TYCO SAFETY PRODUCTS – FIRE DETECTION – ANZ REGION PRODUCT BULLETIN

F3200 GAS RELEASING PANEL CONTROLLER BOARD INTERMITTENT OPERATION CHANGE-OUT REQUIRED

Figure 1 : Location of Microprocessor and 68-pin socket

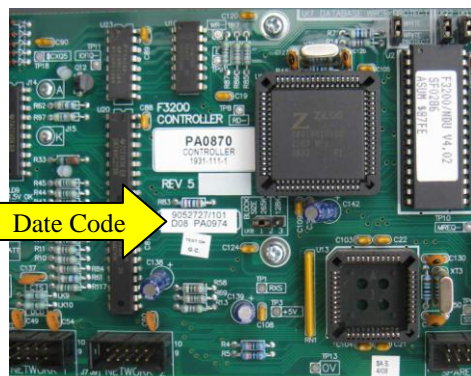
The affected batches of Controller boards are fitted with an unmarked brand of square 68-pin IC socket which has the microprocessor plugged into it (Figure 1). This socket has been identified as the cause of the problem.

Any F3200 Controller Boards from the affected batches (serial number date codes between D07 and I09 inclusive), **used in gas releasing applications, must be exchanged as soon as practicable**, through TSP's normal Returns Authorisation system – contact TSP Melbourne Customer Service on 03 9538 7220. The replacement part number is RPA0909.
